## ADDENDUM NO.3

### INVITATION FOR BIDS FOR CONSTRUCTION SERVICES FOR CAMARILLO STATION AMERICANS WITH DISABILITIES ACT (ADA) IMPROVEMENTS PROJECT

ISSUED June 8, 2026

SHEET  
**DM-01**  
 18 OF 55 SHEETS

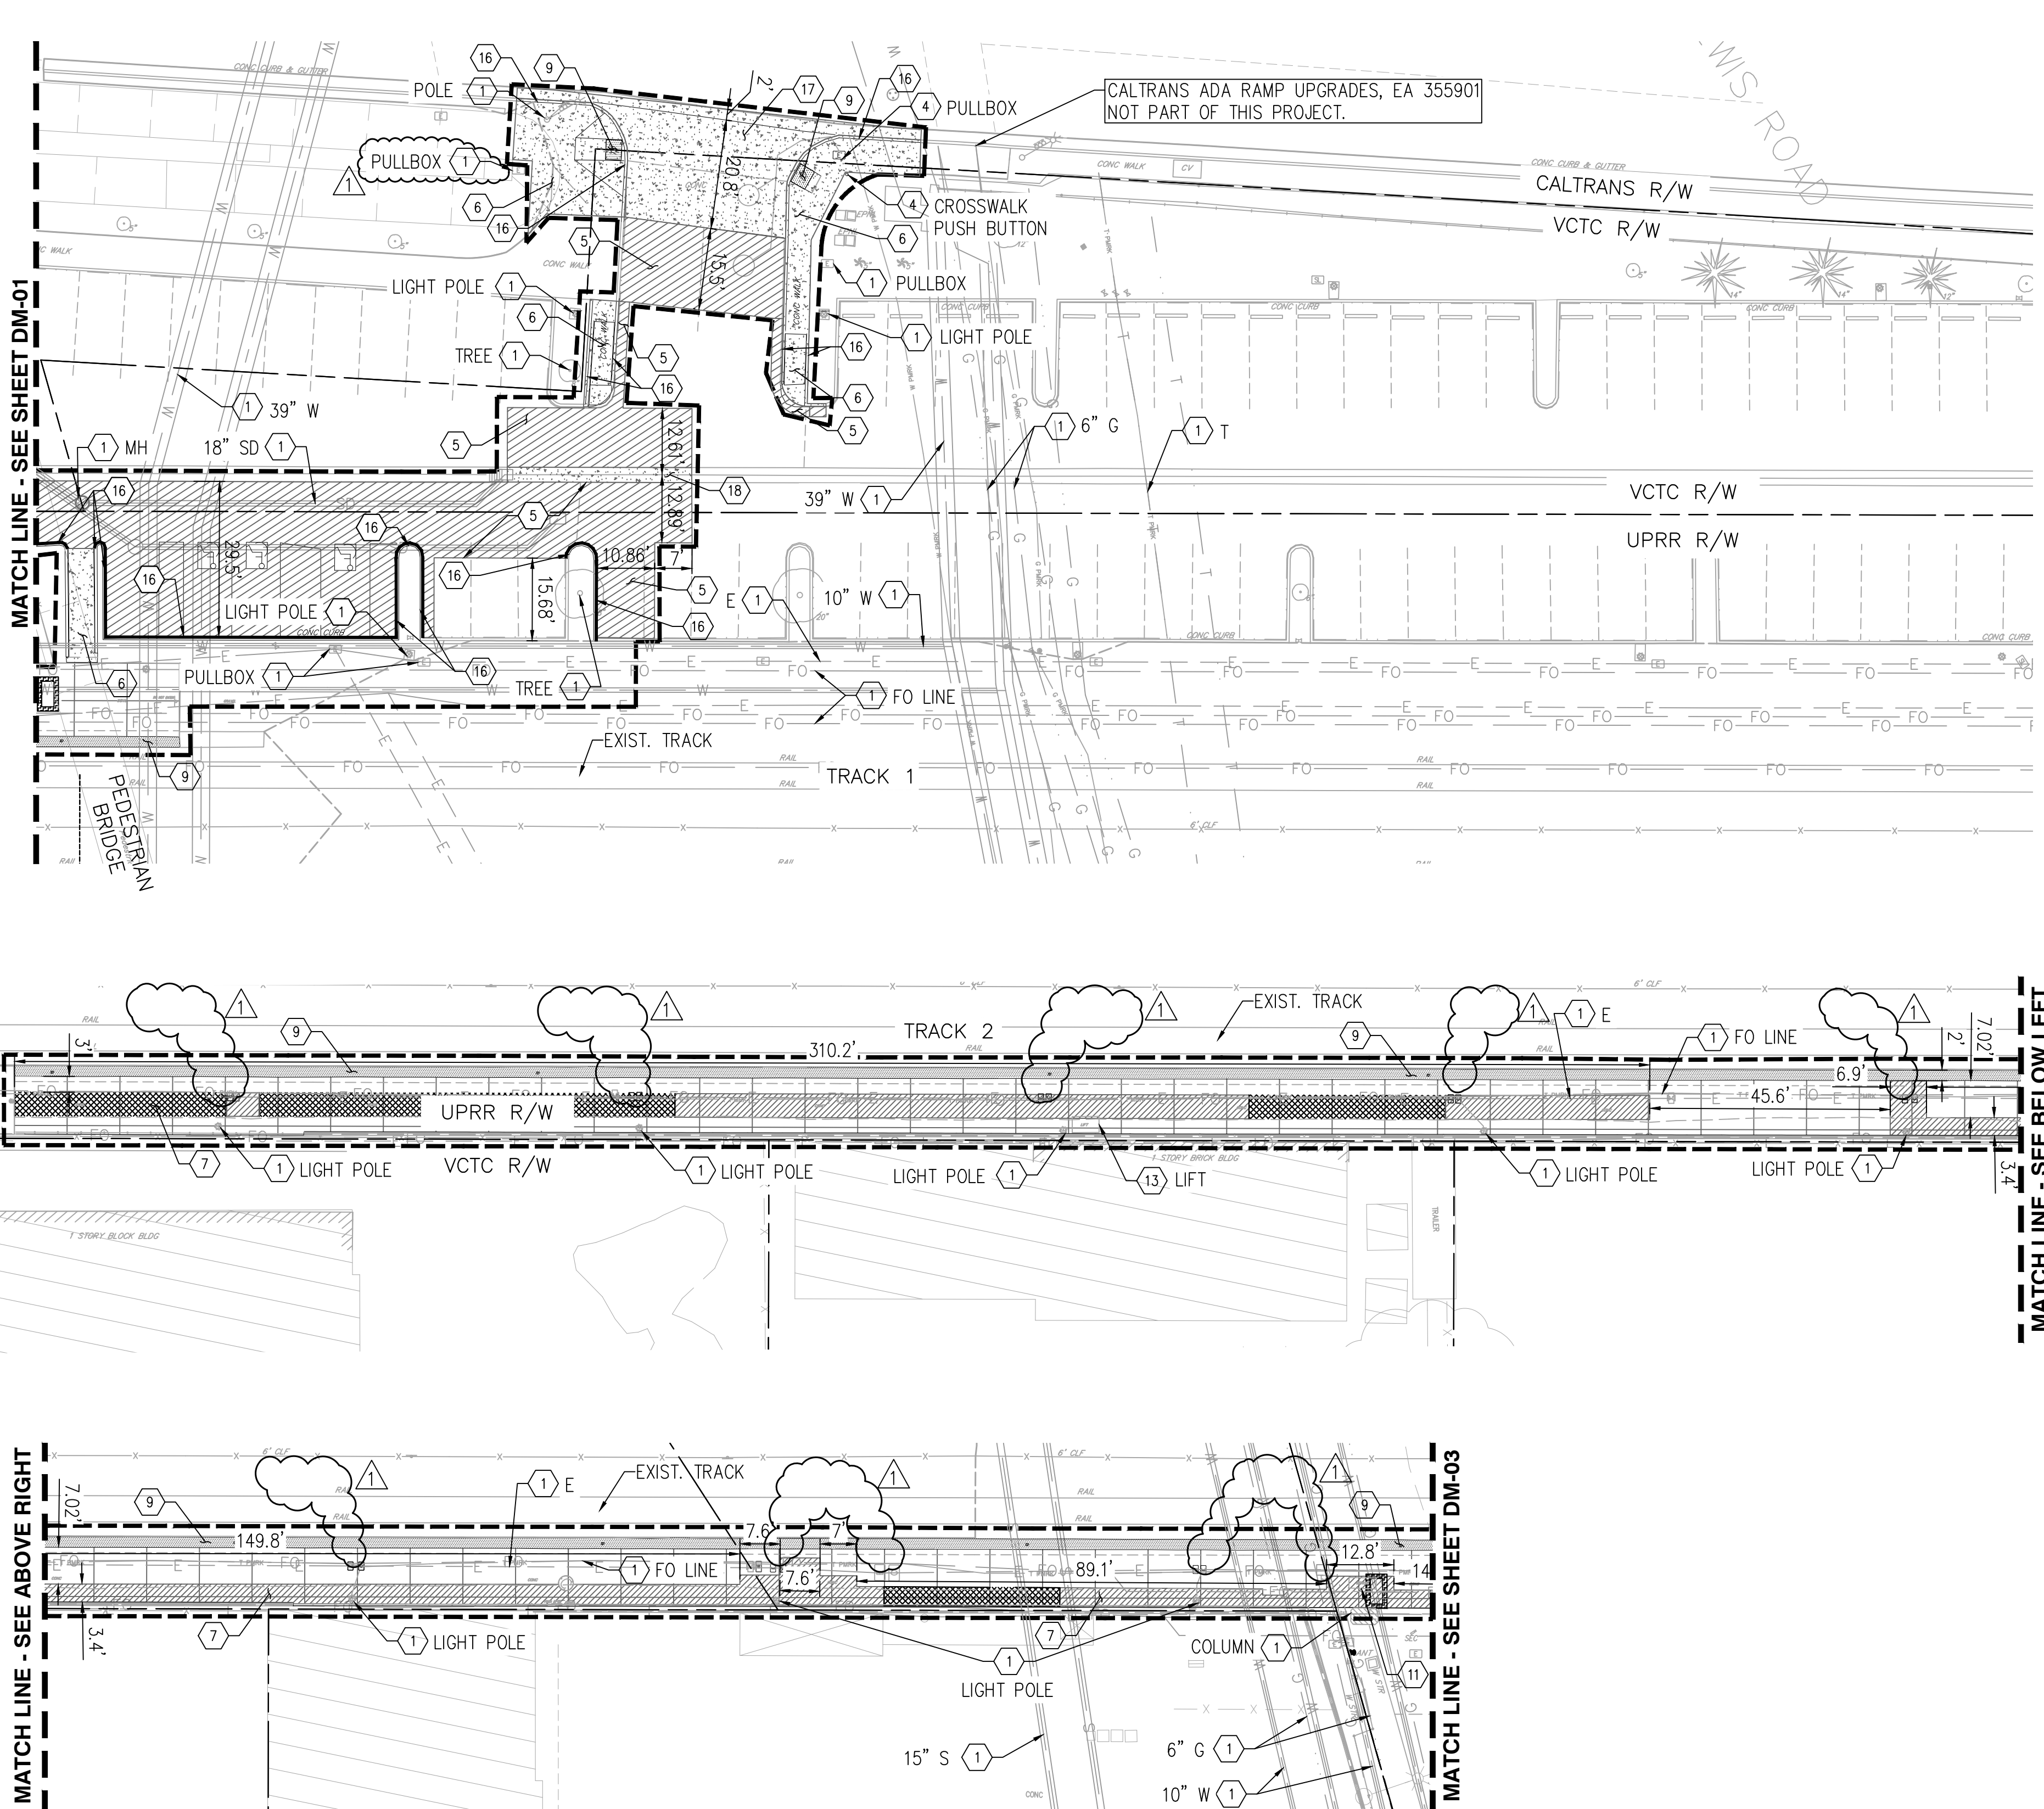
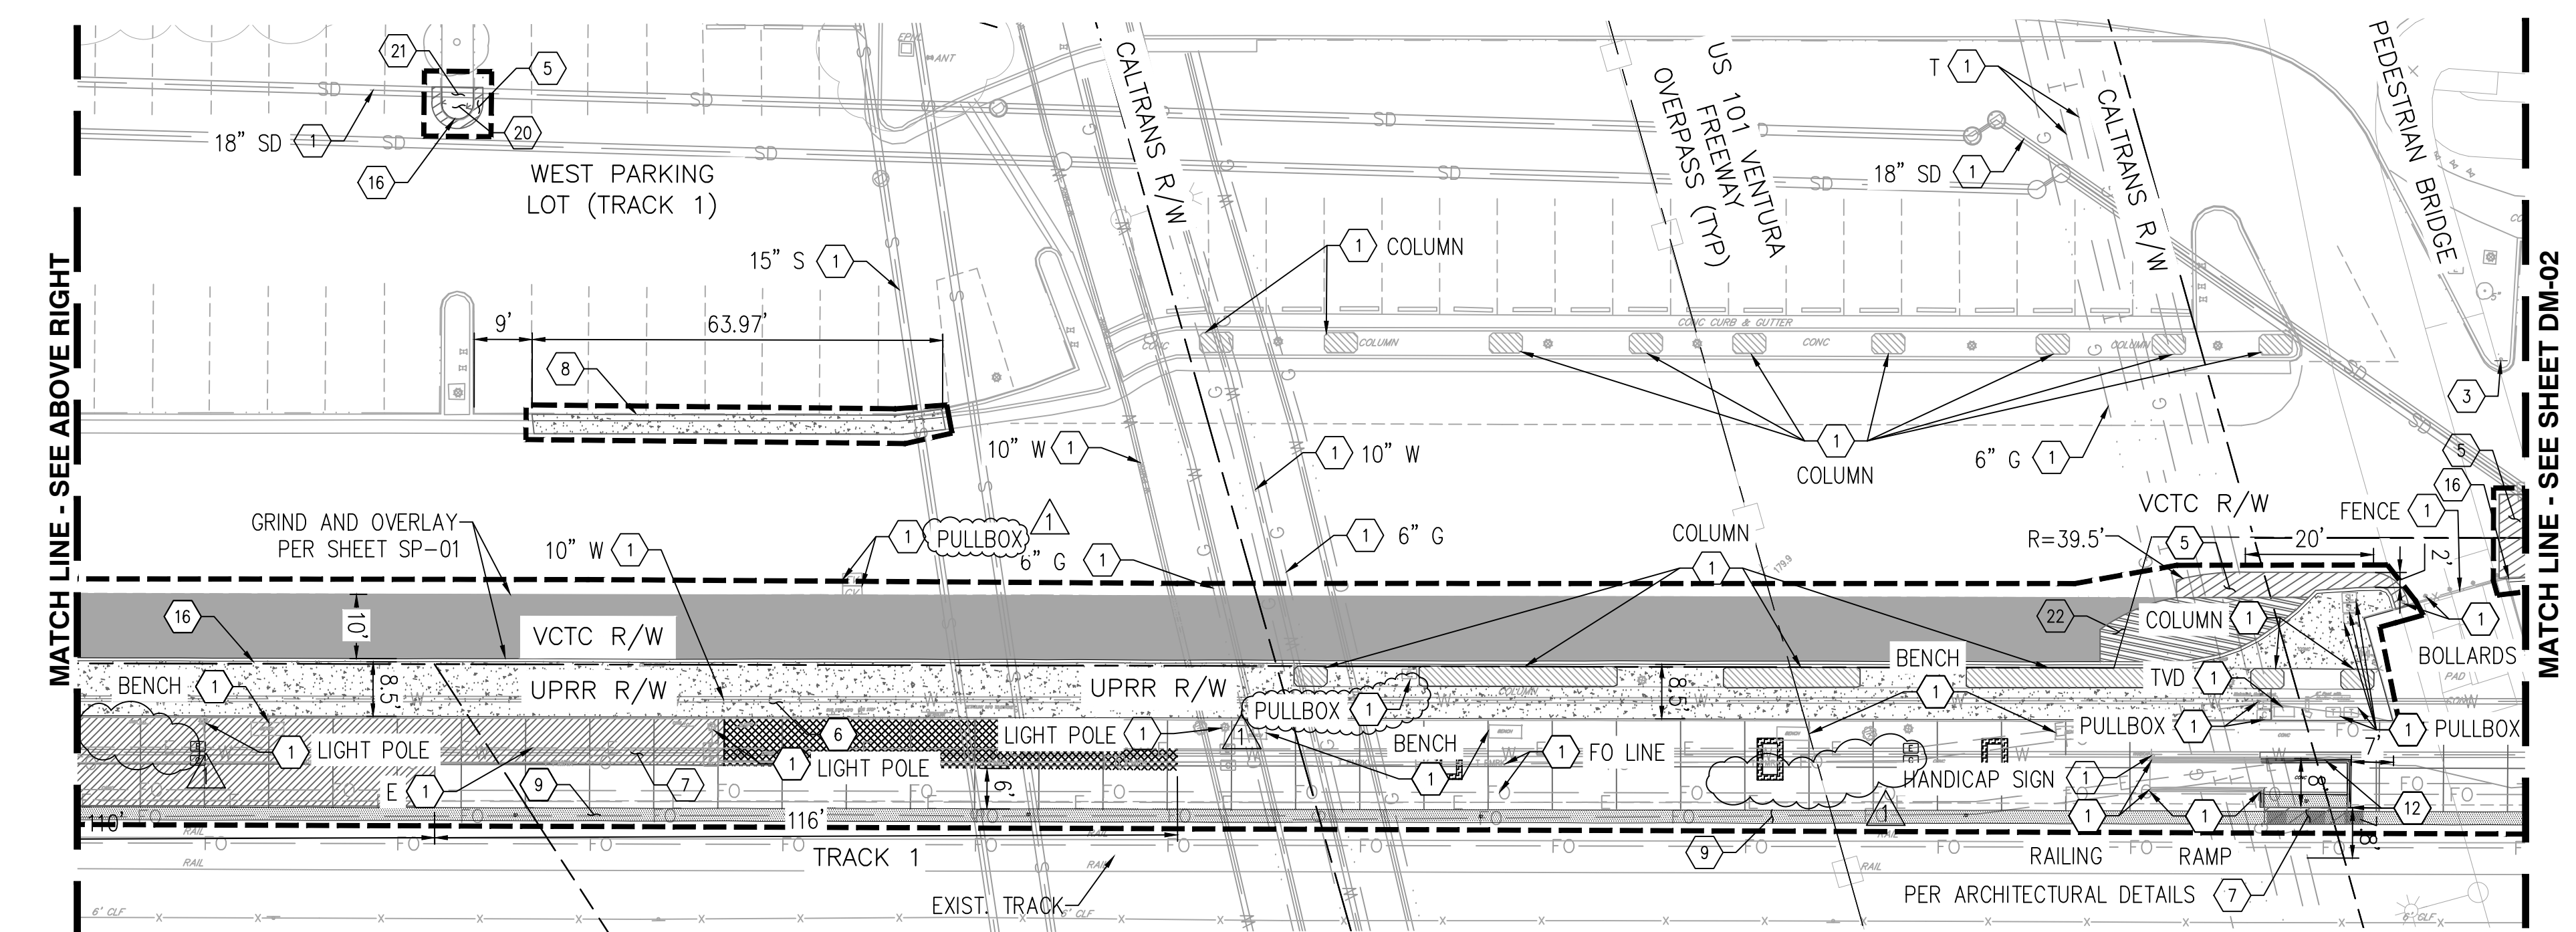
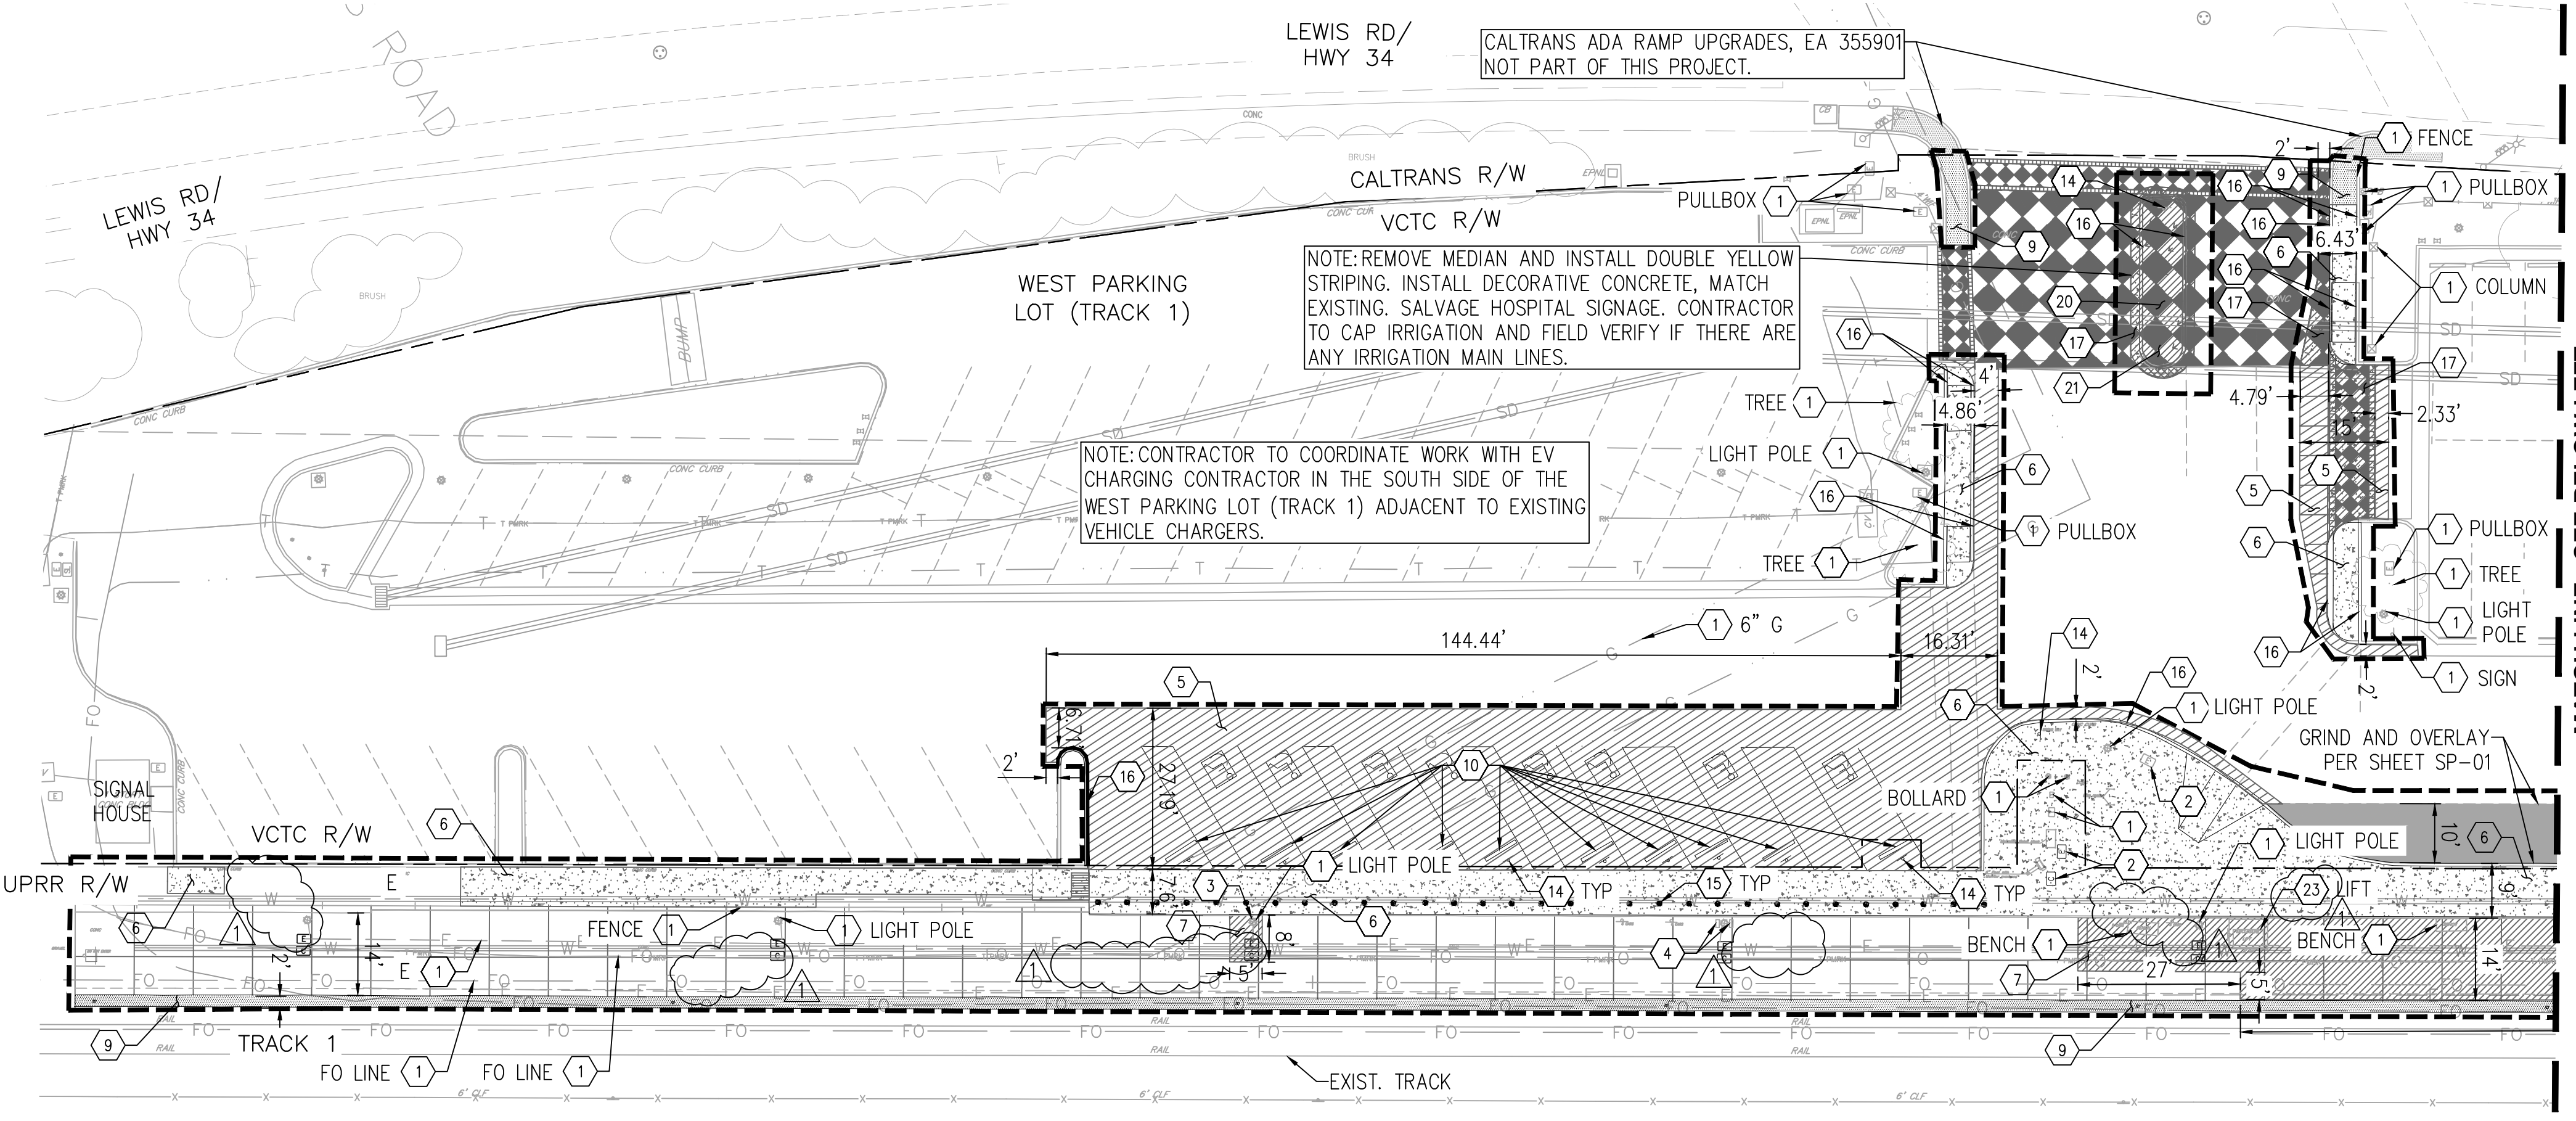
- a. XS-01 Civil Site Typical Sections
- b. DM-01 Demolition Plan Sheet 1 of 3
- c. DM-02 Demolition Plan Sheet 2 of 3
- d. DM-03 Demolition Plan Sheet 3 of 3
- e. SP-01 Civil Site Plan Sheet 1 of 3
- f. SP-02 Civil Site Plan Sheet 2 of 3
- g. SP-03 Civil Site Plan Sheet 3 of 3
- h. A203 Enlarged Platform Plan, Sheet 2 of 8
- i. A204 Enlarged Platform Plan, Sheet 3 of 8
- j. A206 Enlarged Platform Plan, Sheet 5 of 8
- k. A207 Enlarged Platform Plan, Sheet 6 of 8
- l. A208 Enlarged Platform Plan, Sheet 7 of 8
- m. A209 Enlarged Platform Plan, Sheet 8 of 8
- n. A304 Architectural Details, Sheet 4 of 5
